CARRINGTON ROAD IMPROVEMENTS

### **Carrington Road Corridor Upgrade PS - response to Groundwater s92 questions**

## Attachment K: Response to Local Board Comments on Carrington Road Improvements Project Resource Consent Application

Figure 3: Sichert-derived drawdown cones for DN4000 isolation valve chamber excavation (the upper and lower K values are also shown as plausible upper and lower bounds of permeability).

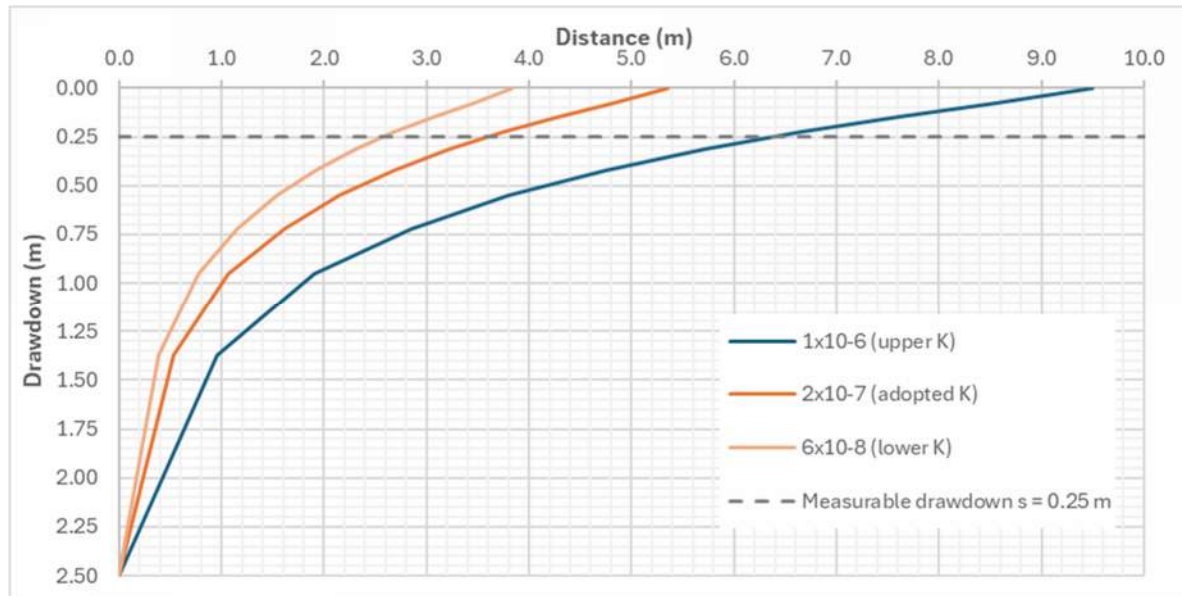
53. *Please note the preparation of profiles, at the critical cross-sections, should show the total (combined) settlement (i.e. the consolidation settlement due to groundwater drawdown plus the mechanical settlement due to retaining wall deflection) beneath the neighbouring buildings/structures and public services. The profiles should be annotated with the calculated maximum differential settlement (slope gradient) across neighbouring driveways, buildings/structures and public services, if any.*

This is shown by the upper K line ( $1 \times 10^{-6}$  m/s) on Figure 3 to provide an upper bound assessment of drawdown. This assessment suggests a potential increase in the extent of drawdown by ~4 m; however, in all cases the calculated extent of drawdown remains less than 10 m.

Figure 4: Cross section through Isolation valve chamber excavation perpendicular to Carrington Road alignment showing maximum calculated extent of drawdown in relation to existing services.

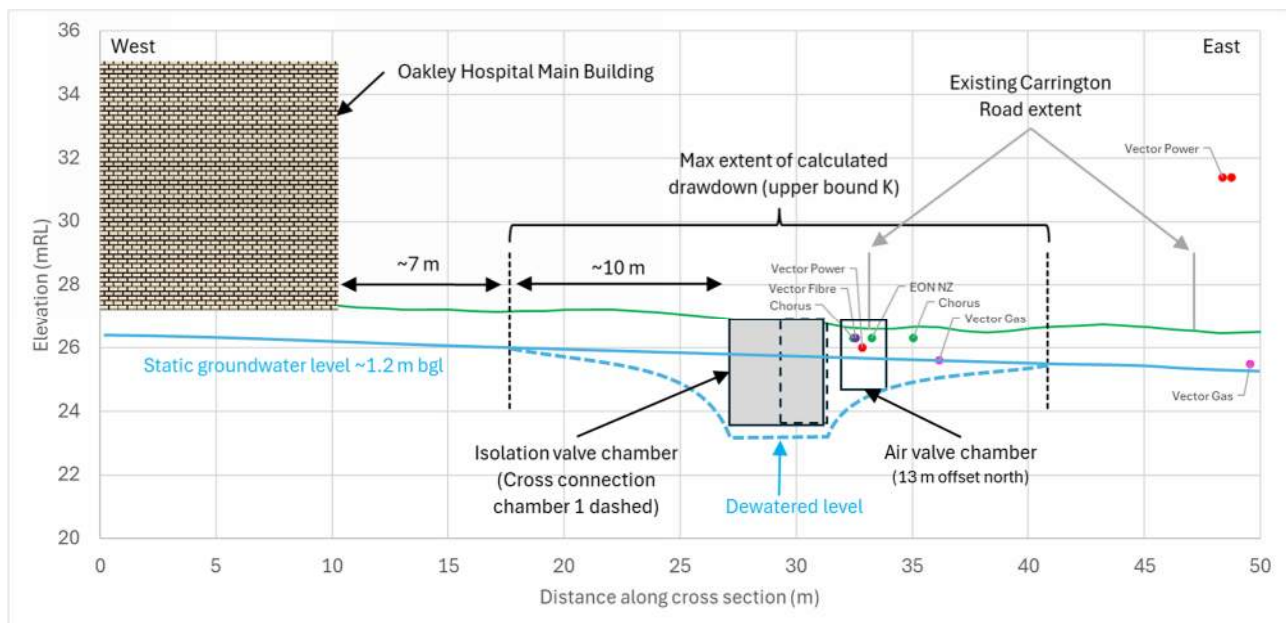
50. *As noted under item 49, please provide a clear isopach earthworks plan to show the location, distribution, and depths of proposed earthworks. The plan must also show the maximum cut and fill depths.*

Cross section presented in Figure 4 of this letter.
